ADDENDUM #2

NORTH TRUCKEE DRAIN REALIGNMENT PHASE 1

BID #13/14-007 – PWP# WA-2014-011

This addendum is to notify all potential proposers of clarifications made to the Bid documents as stated below.

SHEET No. XS-2							
SHT OF

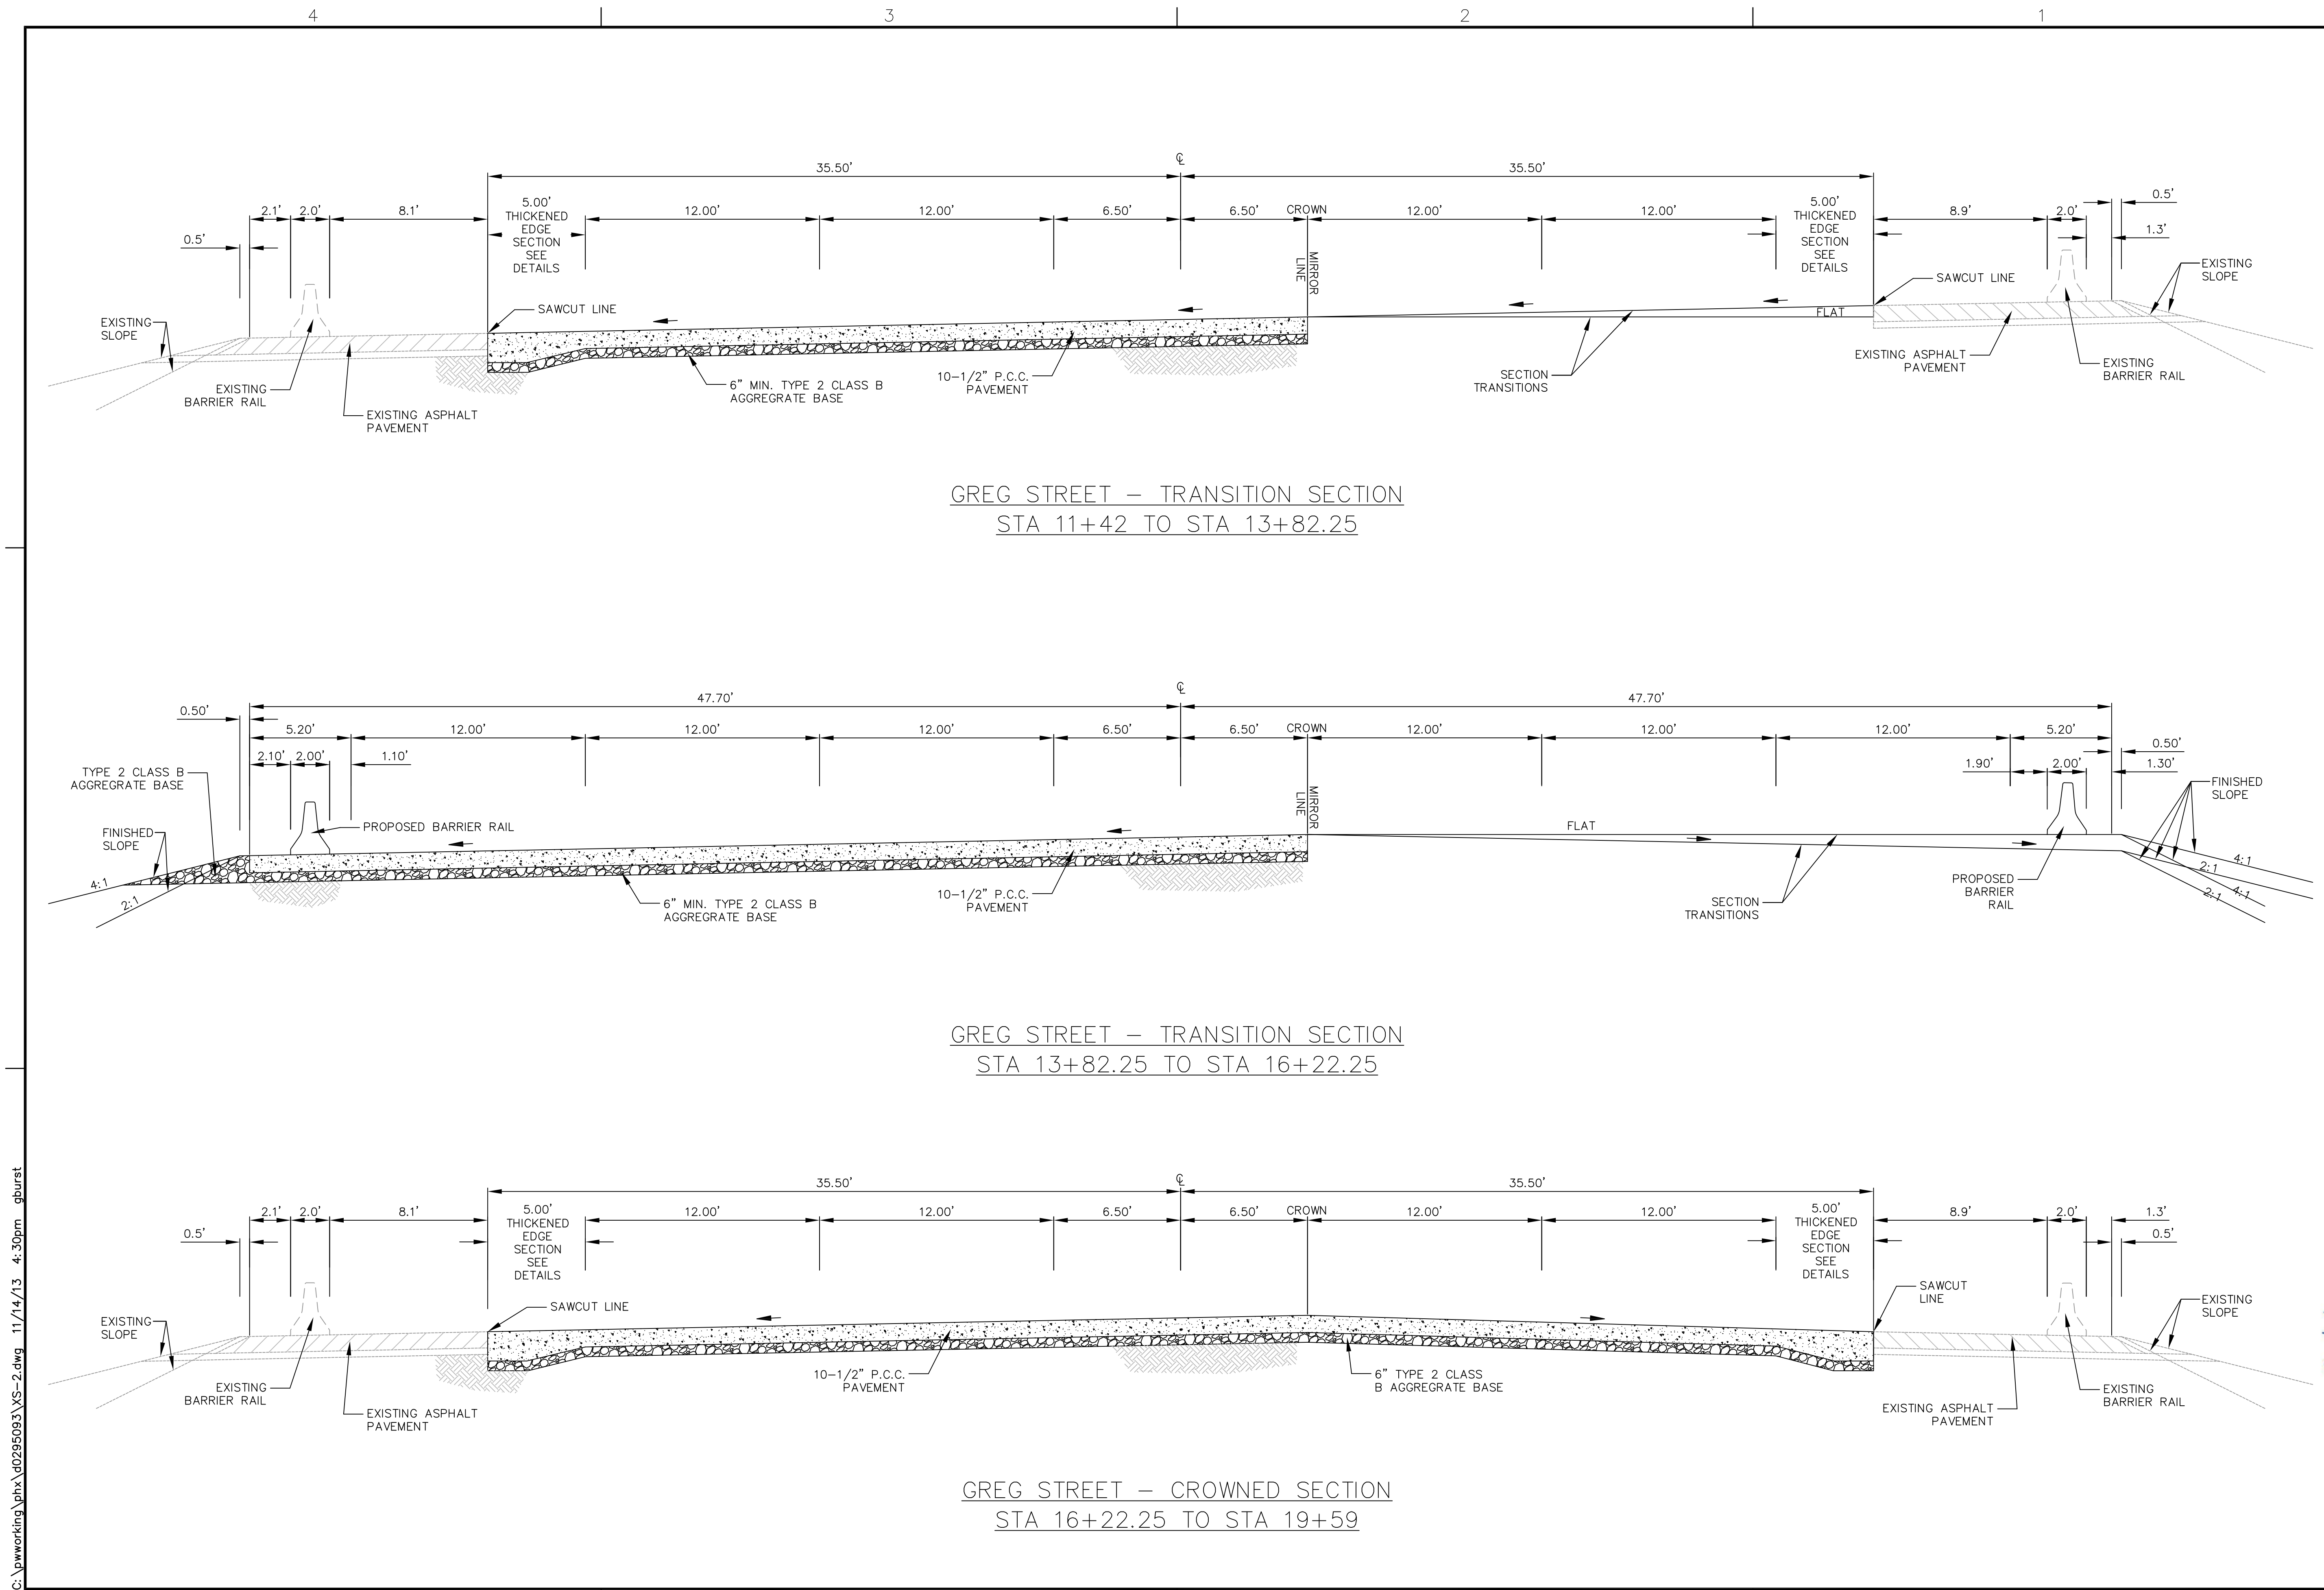
16. Sheet XS-2 – Sheet was changed in its entirety.
17. Sheet DT-5 – Remove the two "Note 11" callouts from the two drawings under the section titled: RCB INSTALLATION SECTIONS

SHEET No. DT-6
SHT OF

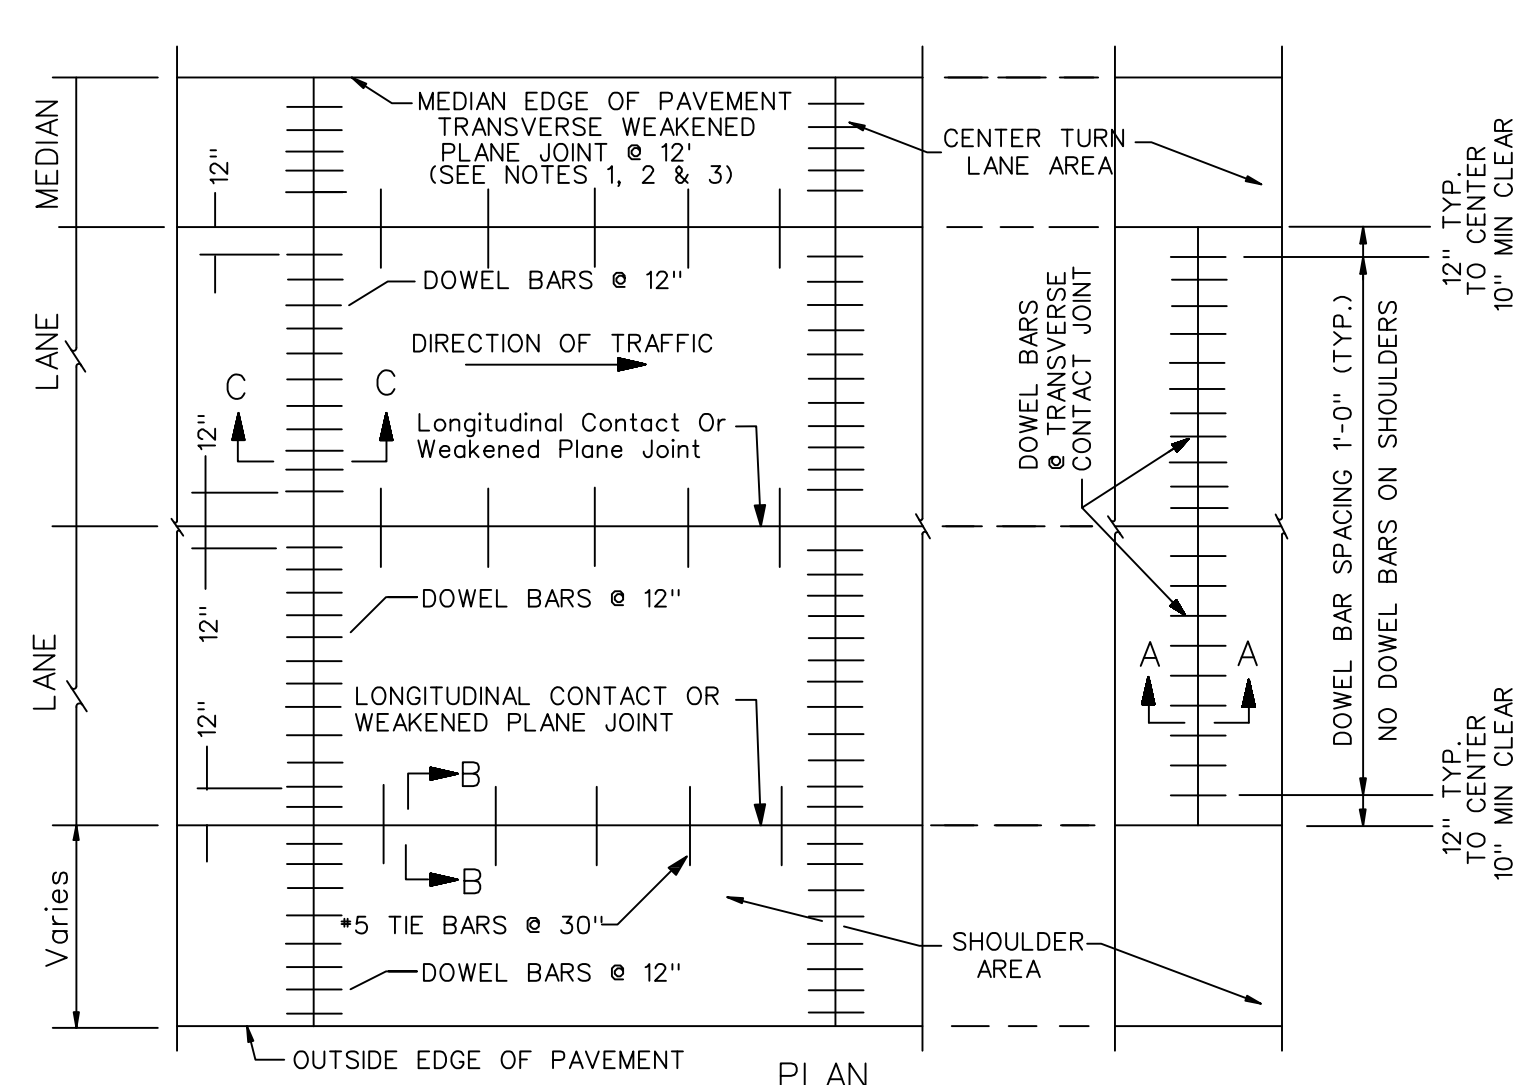
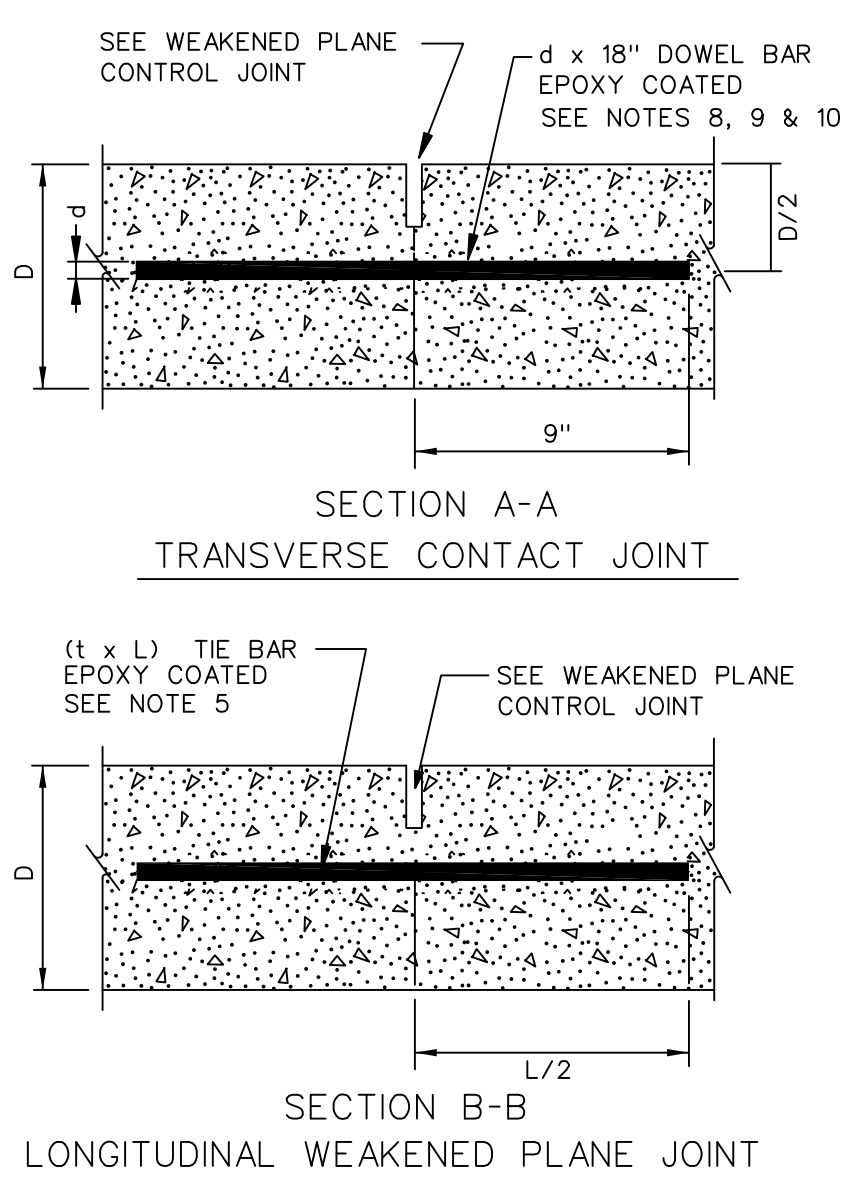
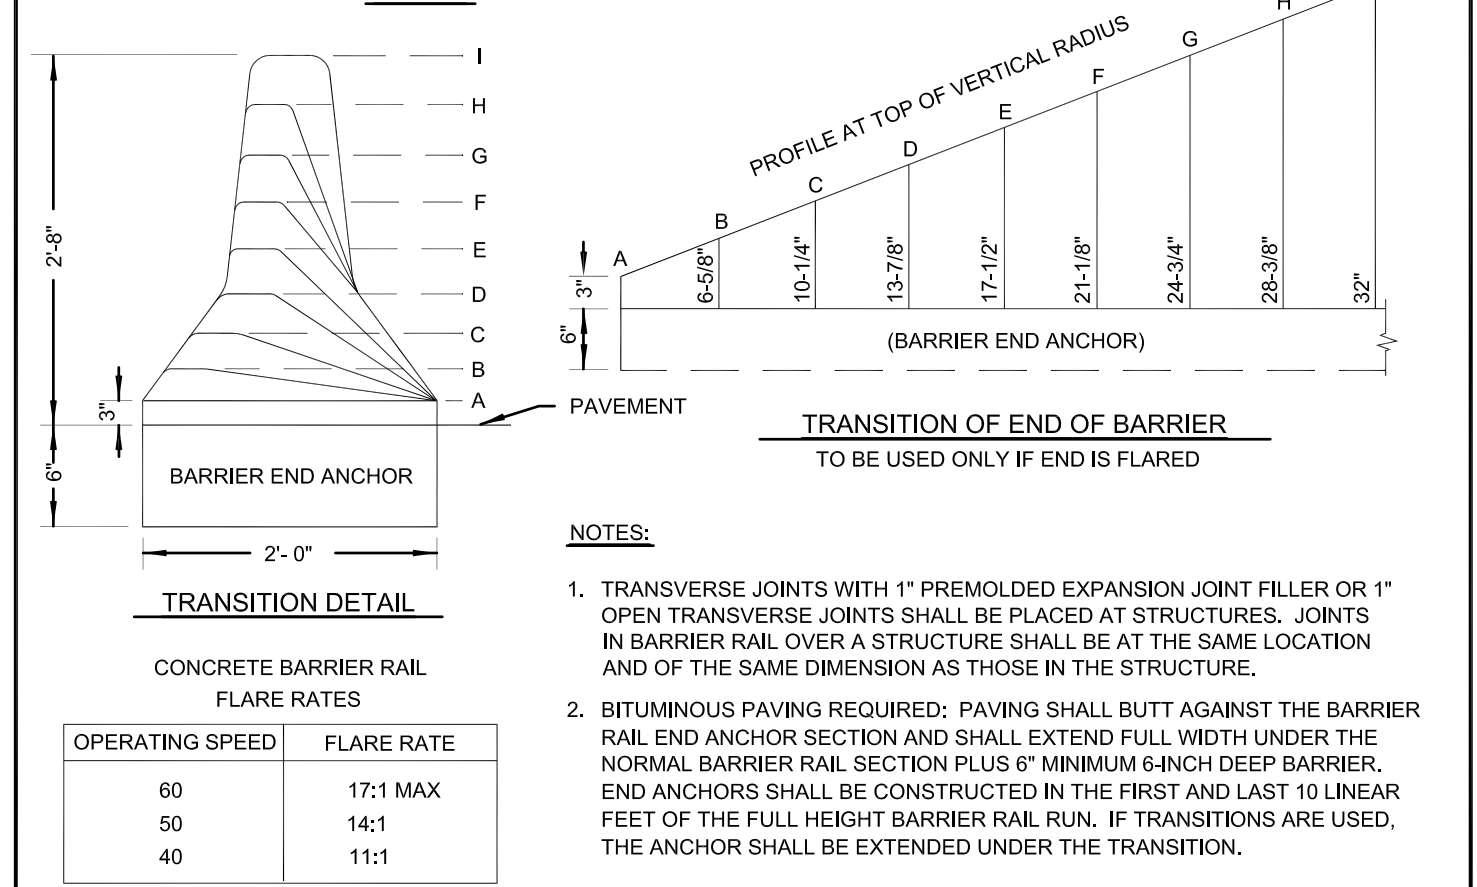
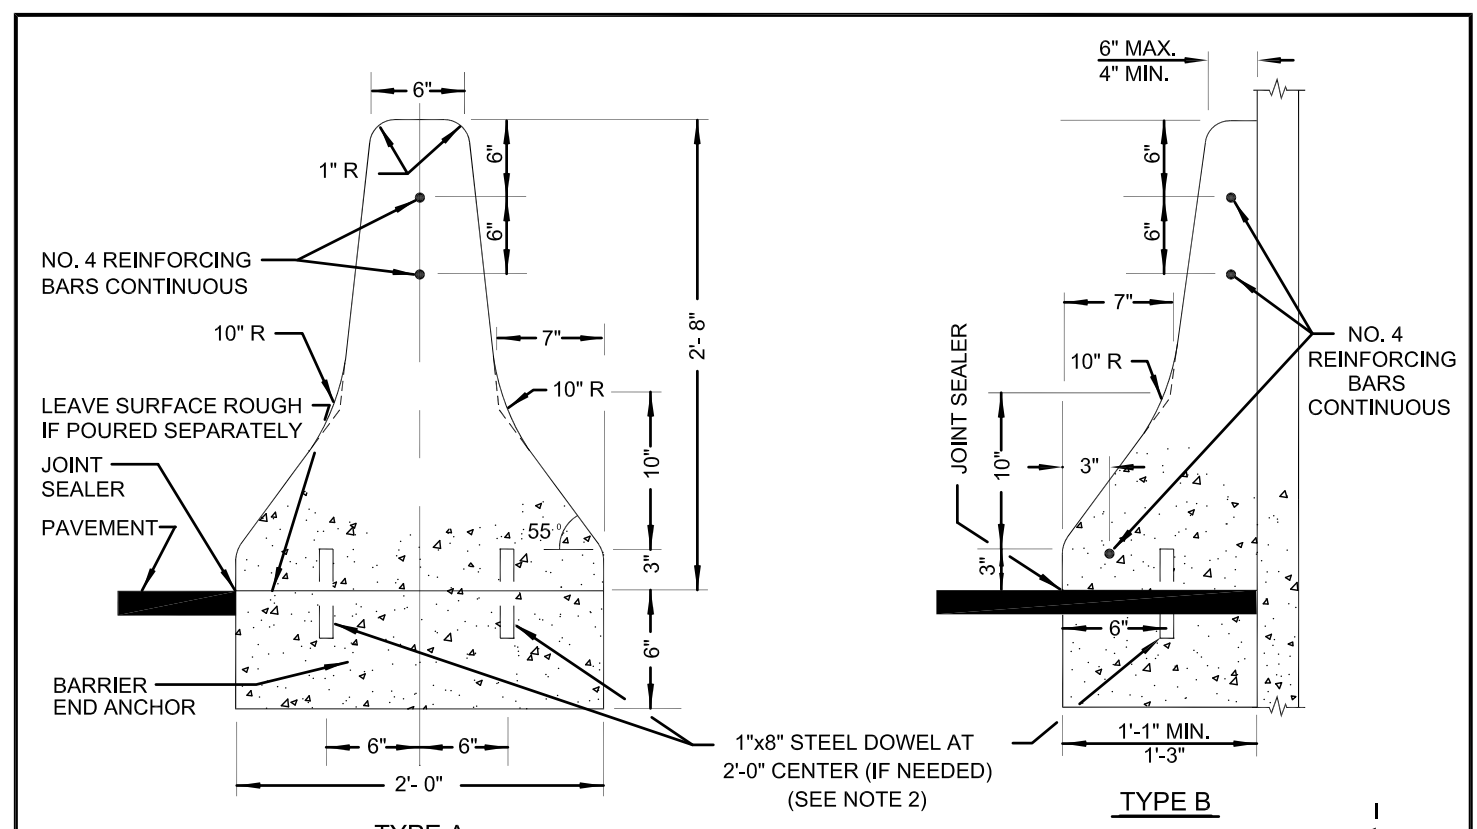
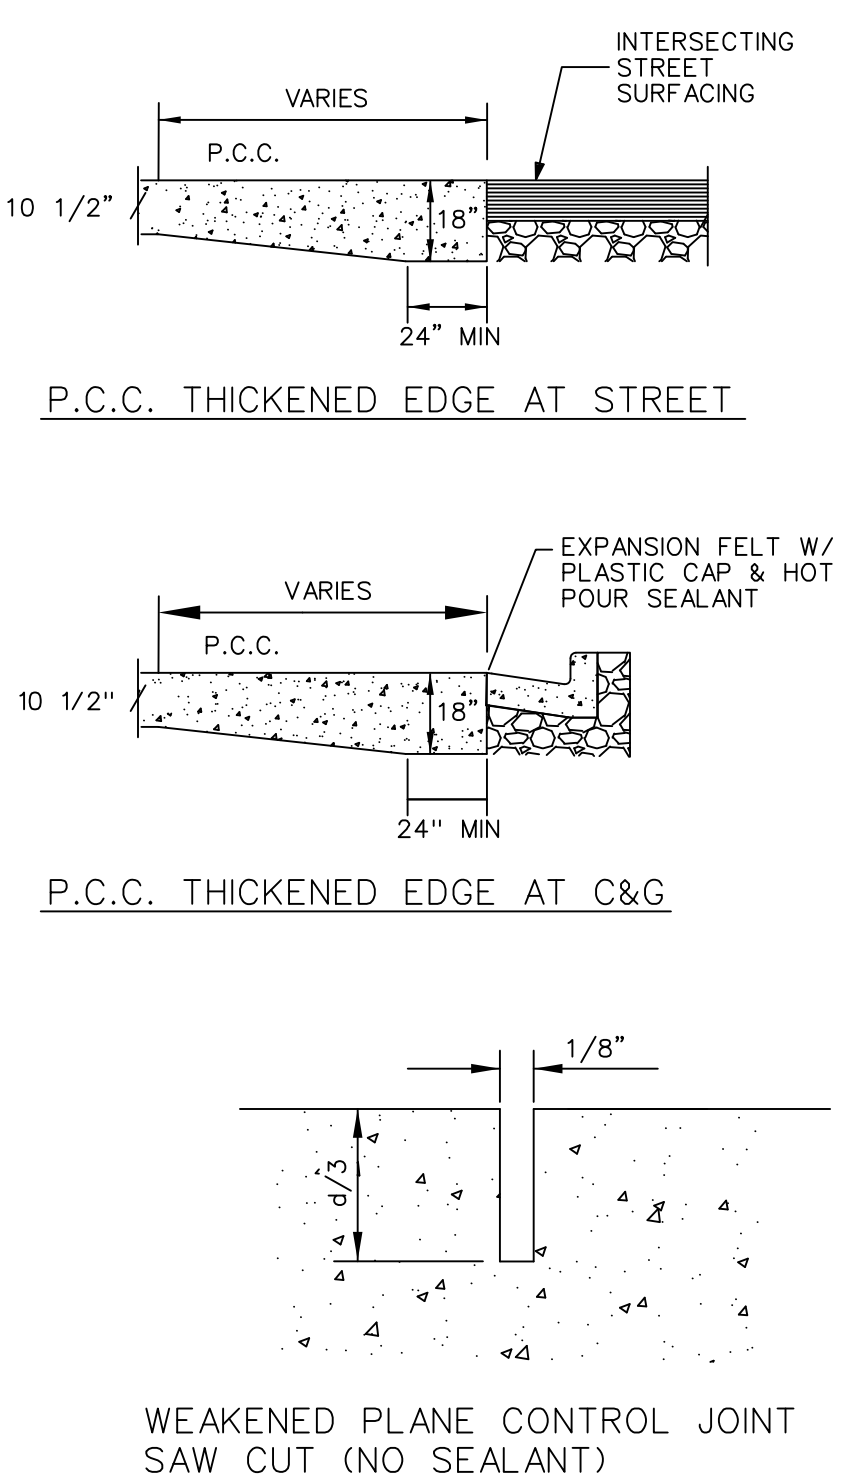
18. Sheet DT-6 – The Portland Cement Concrete details (top half of the sheet) were all removed and replaced.
19. Sheet DT-7 – The lower middle detail titled "Loop Detector Notes, Layout and Details" was added.
